# VILLAGE OF HOMEWOOD

## MEMORANDUM

**Topic:** Cases 26-08, 26-33 and 26-37: Special Use Permit, Variance and Site Plan Review for 7Brew Drive-Through Coffee Shop at 17855 Halsted Street

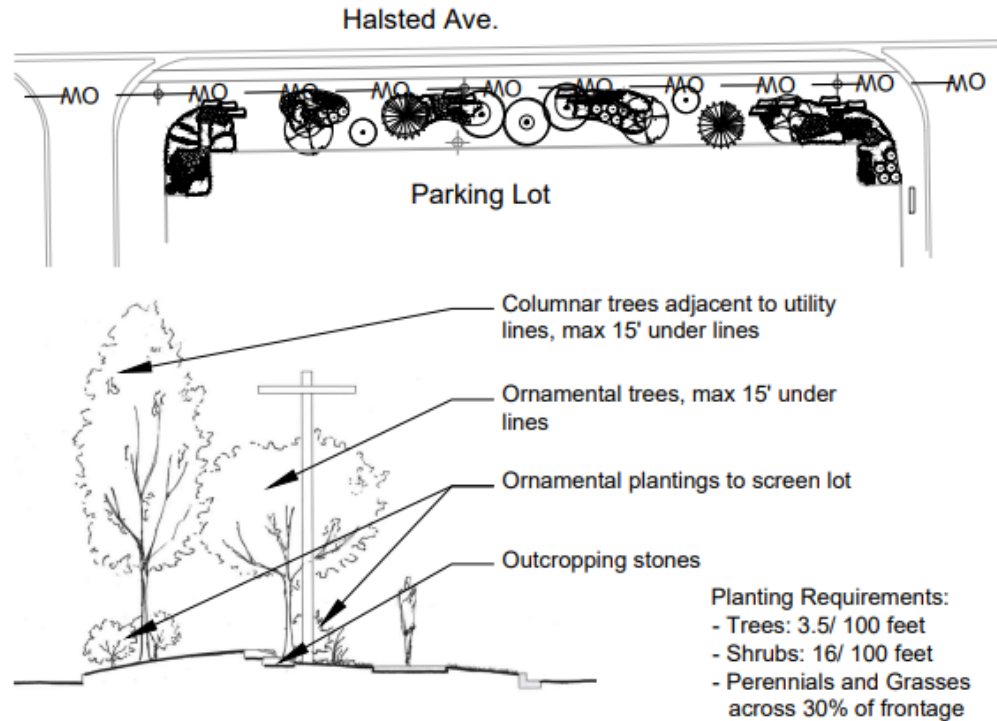
The applicant is required to provide a minimum 15' wide landscape area along Halsted Street as a parking lot perimeter landscape area. This area shall be located between parking spaces and the property line adjacent to the right-of-way of Halsted Street. The frontage of perimeter landscaping required is 210' (existing parking areas remaining after construction are not required to add new perimeter landscaping). This landscape area shall meet the following requirements:

- For every three feet, one shrub or native grass shall be provided – **met required, 57 shrubs and additional native grass areas provided.**
- For every 25' of landscape area length, one understory/evergreen tree shall be provided – **met, 9 provided, 8 required**
- For every 25' of landscape area length, one canopy tree shall be provided – **not met, 7 provided, 8 required**
- The remainder of landscaped area outside of shrubs/plantings shall be planted with live groundcover – **met, multiple groundcovers provided**

The applicant has also provided a perimeter landscaping area which is narrower than the required width for the landscaping area (11' 7" vs. 15'). The applicant has submitted a variance for this reduction in required width, which is reviewed in detail in this memo. The proposed perimeter landscape area meets Village standards, provided the following conditions are met:

1. **The Planning and Zoning Commission and Village Board approve a request for a variance to reduce the required width for the perimeter landscape area from 15' to 11' 7"**
2. **The applicant submits a revised landscape plan which incorporates preferred species from the Village Arborist and replaces one (1) understory/evergreen tree with one (1) canopy tree.**
3. **The applicant submits a revised landscape plan with a full plant list pursuant recommendations of the Village Arborist, including native grasses and groundcovers.**
